CONTEMPLATED CHANGE ORDER

PROJECT	NAC ROOF REPAIRS PHASE 2	DATE	4/26/2021
CONTRACTOR	G&G ROOFING LTD.	CCO. NO.	7

Supplemental Instruction:

Nanaimo Aquatic Centre
Roof Parapet Repairs

Attached - SK 03

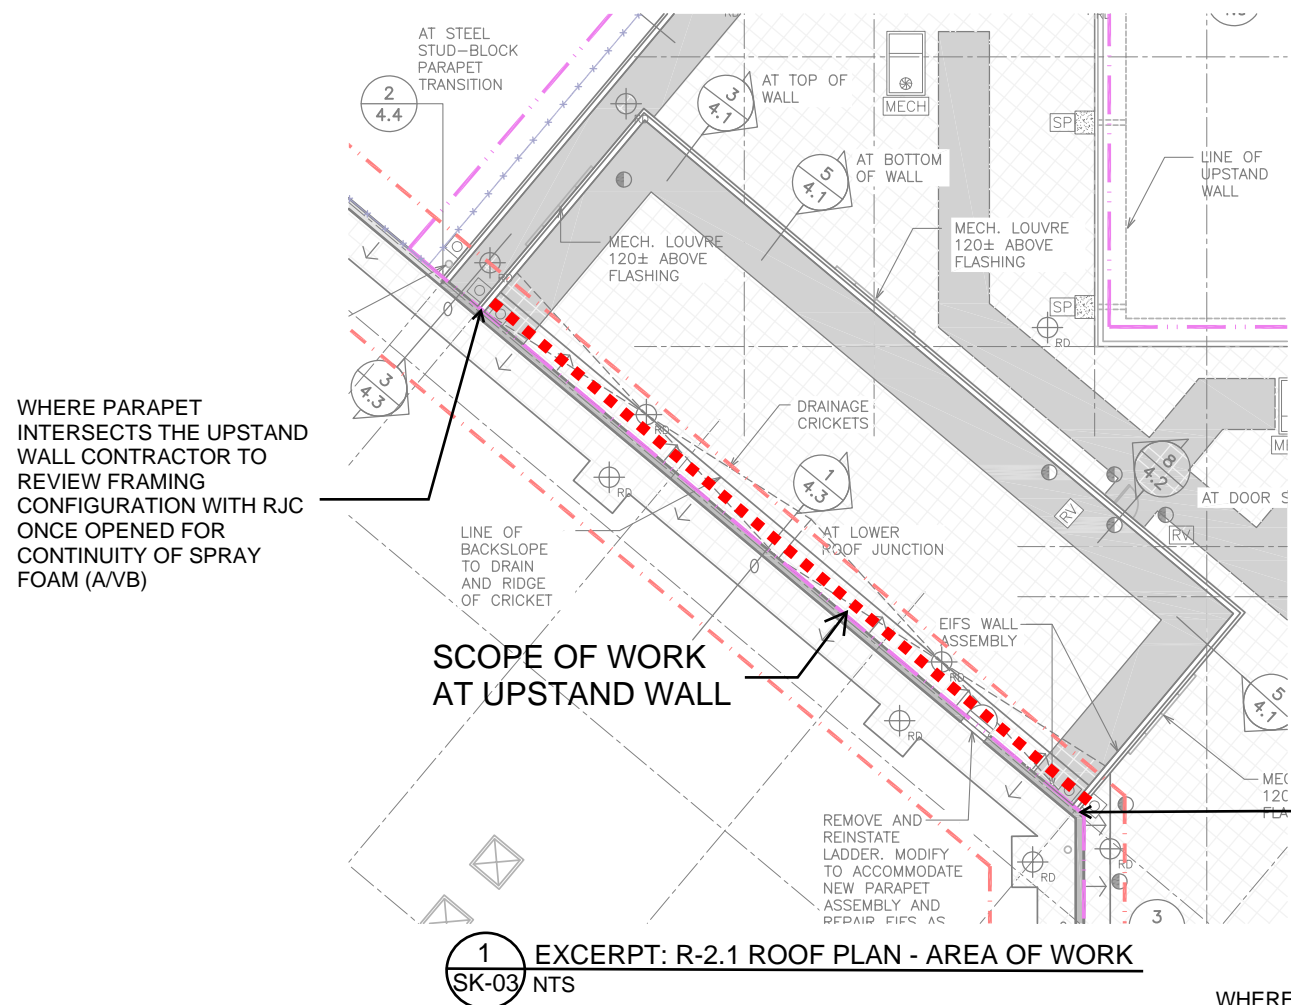
Replace upstand wall detailing in accordance with the attached SK 03 - Upstand Wall. Paint fibre-cement siding to match adjacent EIFS. Replace existing roof sheathing on the entirety of the mechanical mezzanine with new, fibreglass faced gypsum sheathing (Densdeck or approved equivalent).

All existing spray foam to be removed and substrates prepared to as-new condition. Contractor may replace framing members if more cost effective than cleaning. Implications to upper roof to be corrected if framing replacement is selected.

RJC to review prepared framing and substrate prior to application of spray foam. RJC to review upstand wall framing interface with parapet wall at southeast and southwest corners for air and vapour retarder continuity detailing once existing framing is exposed.

Contractor to install spray foam such that spray foam is in contact with the gypsum backing before curing (ie. apply the uncured spray foam to the sheathing). Upstand wall sheathing can be installed in strips to facilitate spray foam installation.

WHERE PARAPET INTERSECTS THE UPSTAND WALL CONTRACTOR TO REVIEW FRAMING CONFIGURATION WITH RJC ONCE OPENED FOR CONTINUITY OF SPRAY FOAM (A/VB)

19mm DOUBLE SIDED FOAM TAPE BETWEEN STEEL STUD STACK AND ANGLE. FASTEN ANGLE TO STUD TRACK THROUGH FOAM TAPE WITH 12mm SELF-TAPPING SCREWS

25x100-20ga GALVANIZED STEEL ANGLE. LAP VB ONTO LEG OF ANGLE
